## **SERVICE BULLETIN NO. 00-04**

This Service Bulletin defines the requirements to perform a one-time visual inspection for the purpose of locating cracks in the firewall (part A), install repairs on cracked firewall area (part B), and strengthen the engine cowl strip retention (part C).

The affected models are aircraft CH 2000 serial numbers 20-002 to 20-0047

Fig. 1

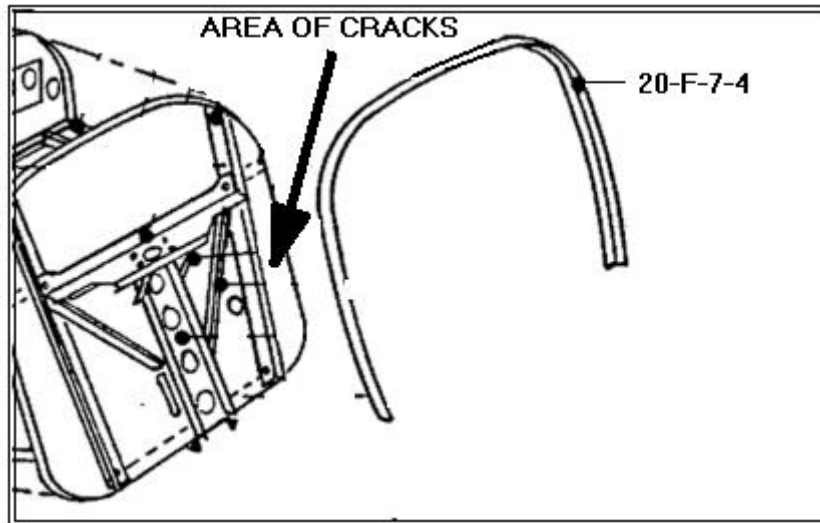
Visually inspect the firewall, from the inside of the cabin, for cracks originating from the fastener holes for the rivets securing the engine cowl strip P/N 20-F-7-4 to the left-hand and right-hand firewall sides. Refer to Fig. 1. If cracks are found, perform Part B of this Bulletin

Fig. 2

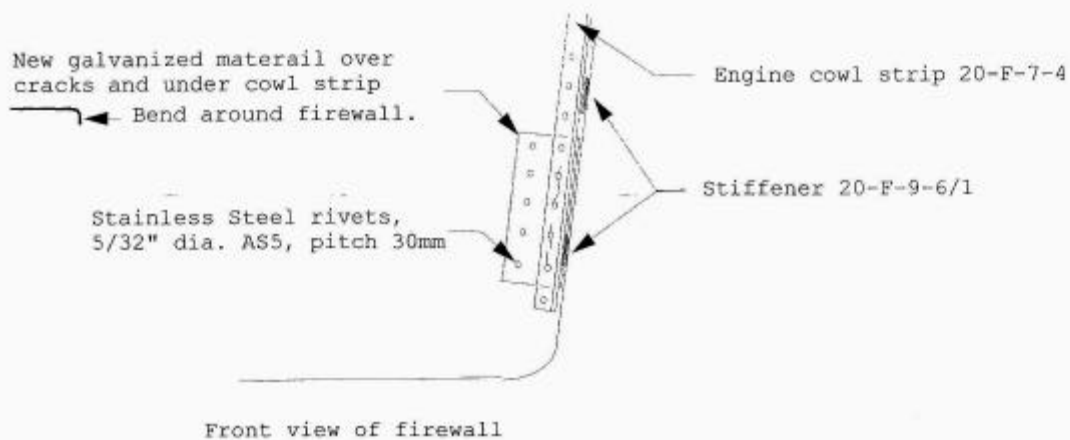
To strengthen the retention of the cowl strip, stainless steel stiffeners are to be installed in the area of the two lower cowl nut-plates on the left-hand and right-hand sides of the aircraft. Refer to Fig. 2 and Fig 4.

1. Obtain four stiffeners P/N 20-F-9-6/1 or manufacture four stiffeners from stainless steel plate as per Fig. 3. Apply zinc chromate coating to both sides and edges of the stiffeners.
2. Remove existing stiffeners from the lower cowl nut-plate area on both sides of the aircraft.
3. Install the new stainless steel stiffeners by aligning them to the lower two nut-plates on both sides of the lower cowl strip. The stiffeners are to be installed to the inside of the fuselage and to the outside of the cowl strip. Rivet each stiffener in place using five (5) AS5 stainless steel rivets to the fuselage side and two A4 rivets, counter-sunk to the nut-plate.
